DRAFT PLAN OF SUBDIVISION - ZONING BY-LAW AMENDMENT

3849 CAMPBELL STREET NORTH, file 39T-23502/Z-9614

EIS by MTE dated April 24, 2023 Reviewed by ECAC members S. Evans and S. Levin, Sept 29, 2023

FIGURE 10

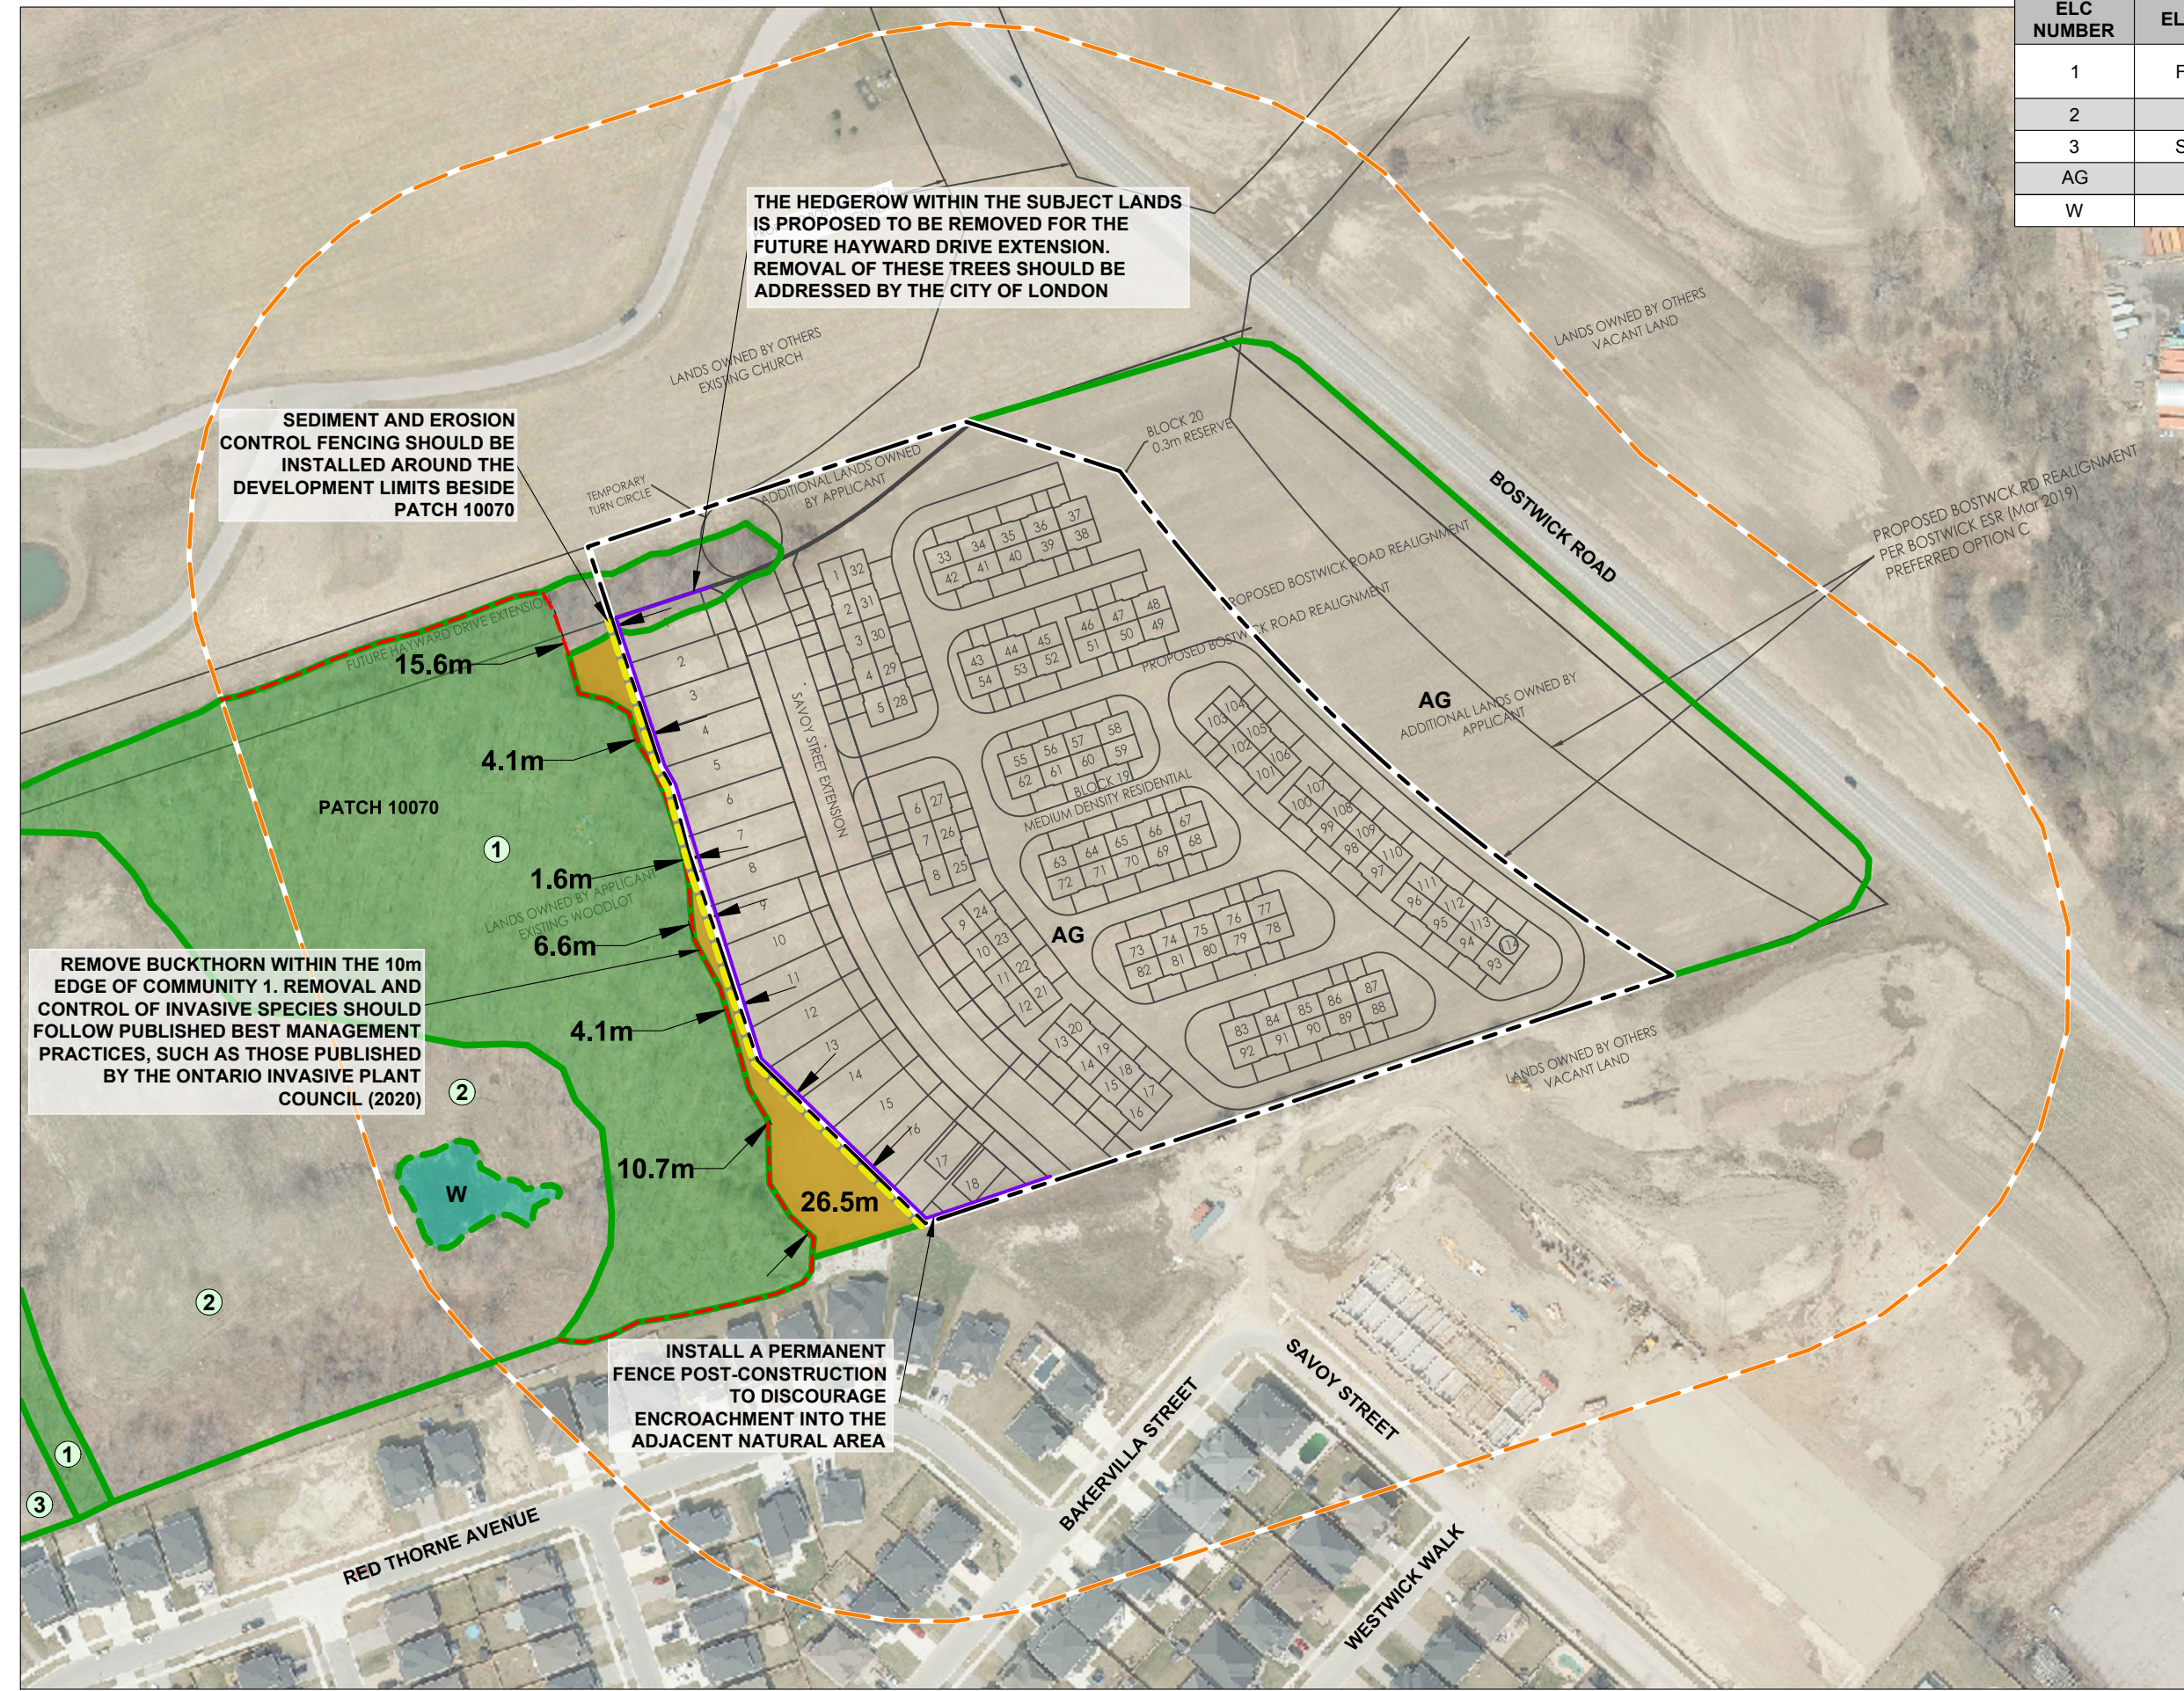
First off, in no way is a 2 m buffer (from figure 10 it appears the proposed buffers range from 1.6 m to a max of 26.5 in the south portion of the site) from the rear lot lines sufficient even where less than the minimum buffer is contemplated in the EMGs. Construction impacts are highly likely and as shown in the recent work done for the City by Dougan, the worst impacts of encroachment are within the first 10 m from a lot line (also found in many studies of developments in SW Ontario by McWilliam – see citation at end – and others). Secondly, to suggest that rear yards can function as buffer is not supportable as individual homeowners are never permanent and the success of “education” has been less than sterling.

RECOMMENDATION 1: The development proposal be changed to provide the buffering required under the EMG for a Significant Woodland.
